MIL-I-7723B
AMENDMENT 2
30 December 1971
Superseding
Amendment 1
1 June 1967

MILITARY SPECIFICATION

INDICATOR, TEMPERATURE, ELECTRICAL RESISTANCE,
MULTIFUNCTION, -70° TO +150°C, DUAL

FIGURE 1. DIAL, POINTERS, AND MARKINGS

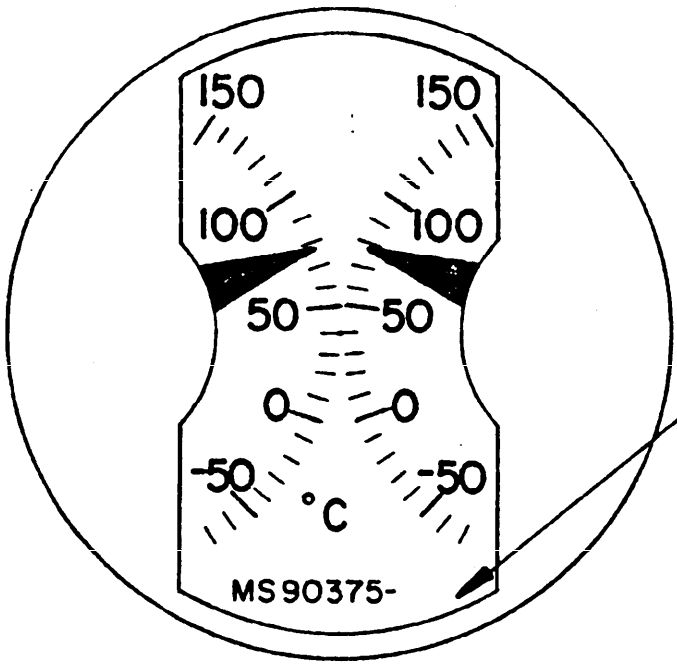
Delete Figure I and substitute the new Figure I on page 2.
